200 Aldington Road Industrial Estate (SSD-10479)

Amended Development Report

Fife Kemps Creek Pty Ltd

Figure 1 Final Concept masterplan

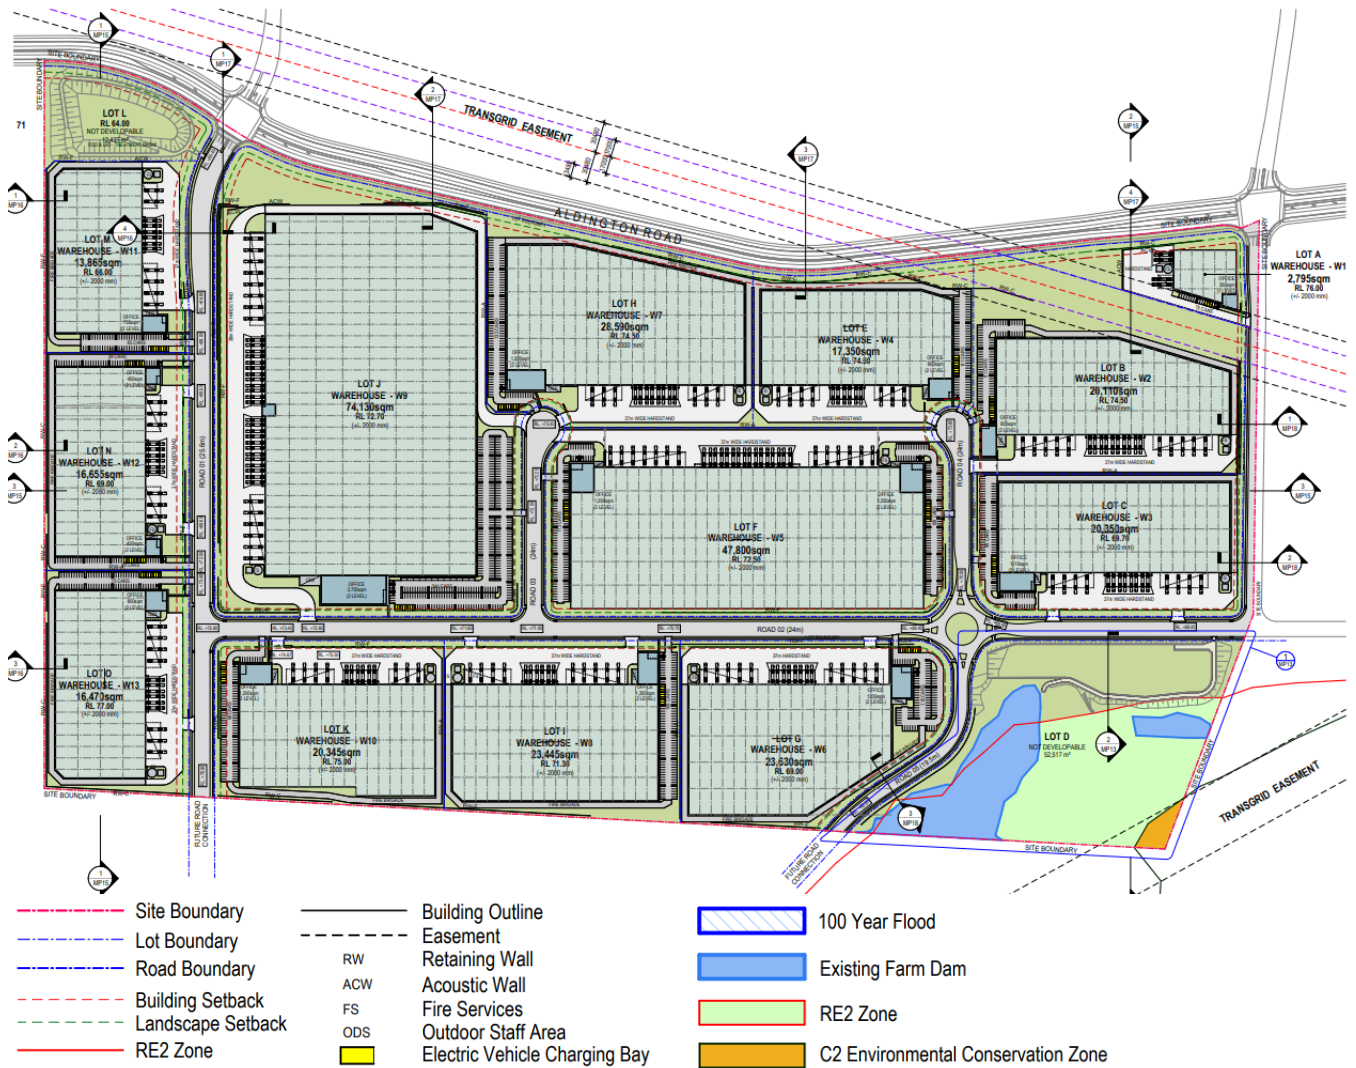
The additional changes to the Concept masterplan plan which form part of this Amendment Report include introducing an additional use (general industry) and minor amendments to the envelope setbacks within Lot A and re-alignment of trunk drainage to outside of the road reserve.

How the Concept masterplan has changed is summarised in **Table 2** and **Table 3**. The final Concept masterplan is shown in **Figure 1**.

Figure 2 Final Stage 1 Plan

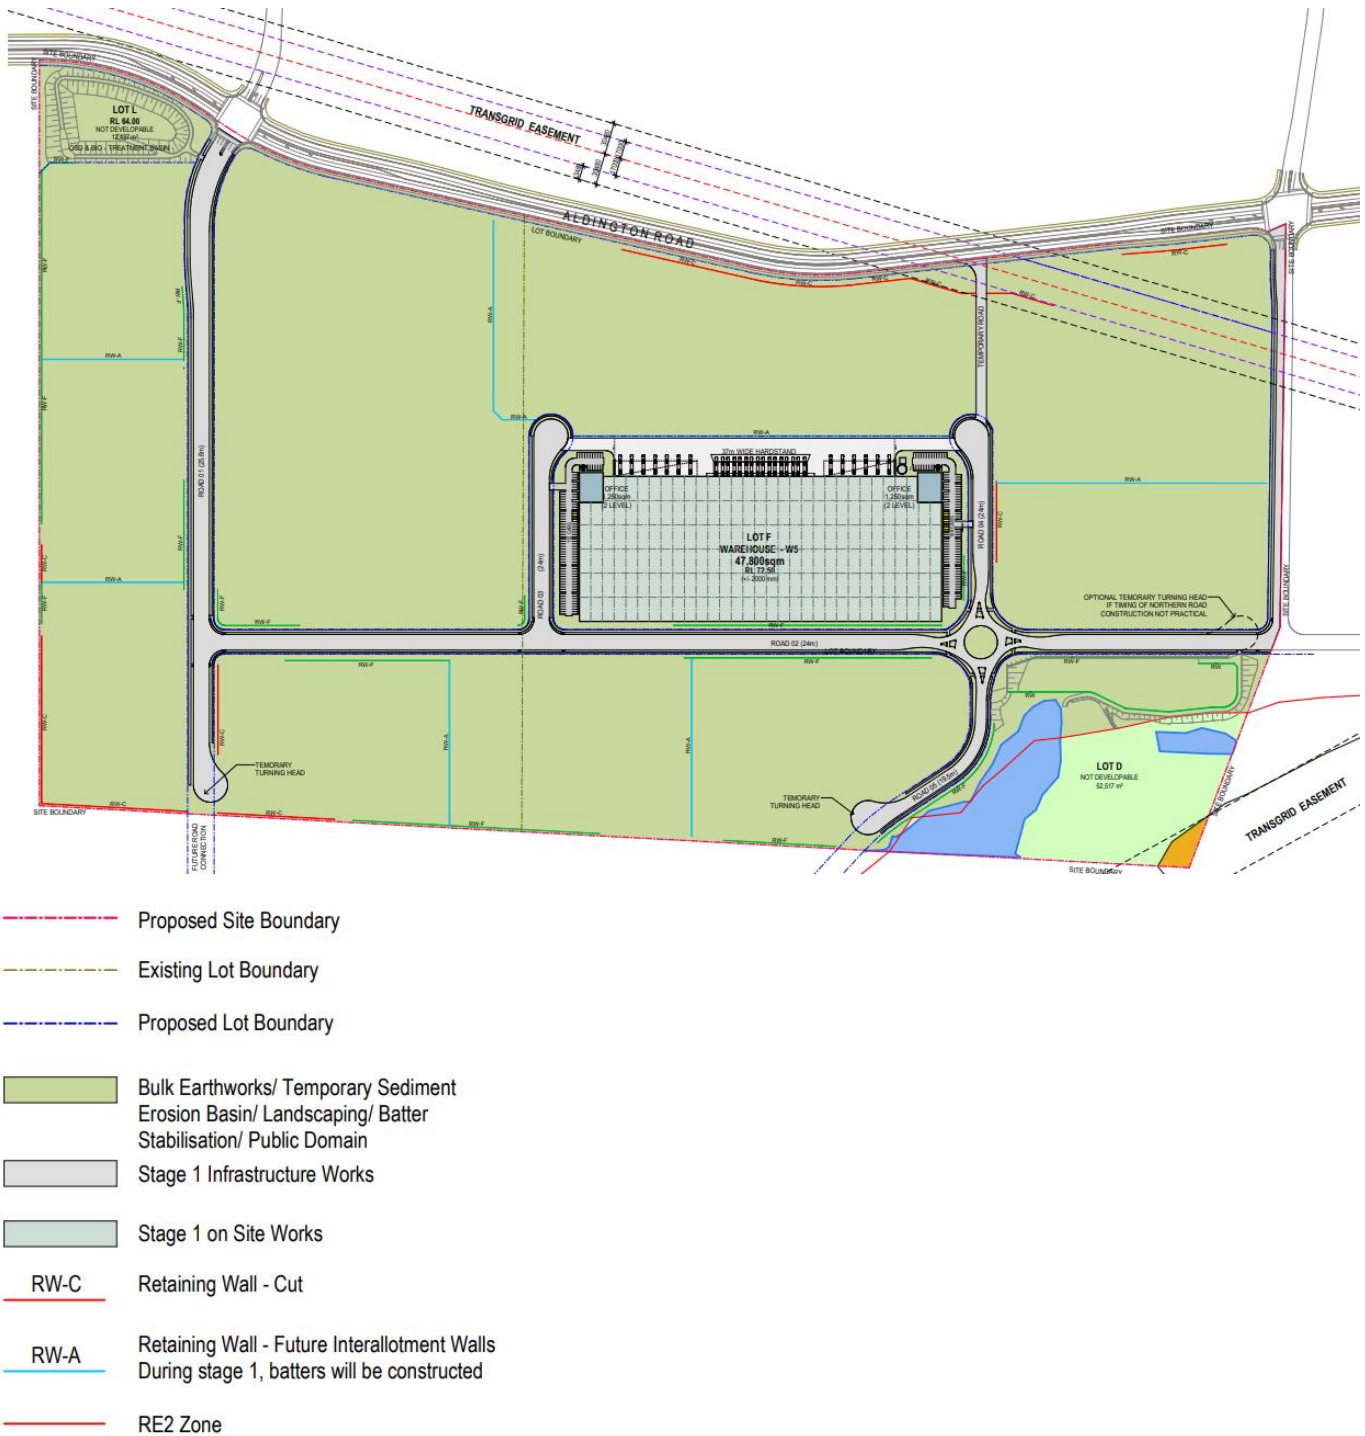
The changes to the Concept masterplan over time has necessitated consequential amendments to the Stage 1 Plan and scope of works (refer to **Table 4** and the final Stage 1 Plan shown in **Figure 2**). The key material change as part of the second Response to Submissions was the inclusion of an interim access road and temporary junction connecting to Aldington Road in the northern portion of the site to facilitate site access prior to the implementation of the northern boundary road.

The Interim Access Road is required at the commencement of the development to facilitate construction and the orderly development of the site. The initial construction for the Stage 1 works will be located in the northern section of the site, owing to the timing of the release of lots for development under agreements with current landowners, and the requirement for utility infrastructure upgrades and connections to the site to be from the north. The road has been considered as part of the traffic impact assessments undertaken for the site and civil works and consultation and in principle support has been received by TransGrid (given the interim road will sit within their current easement).
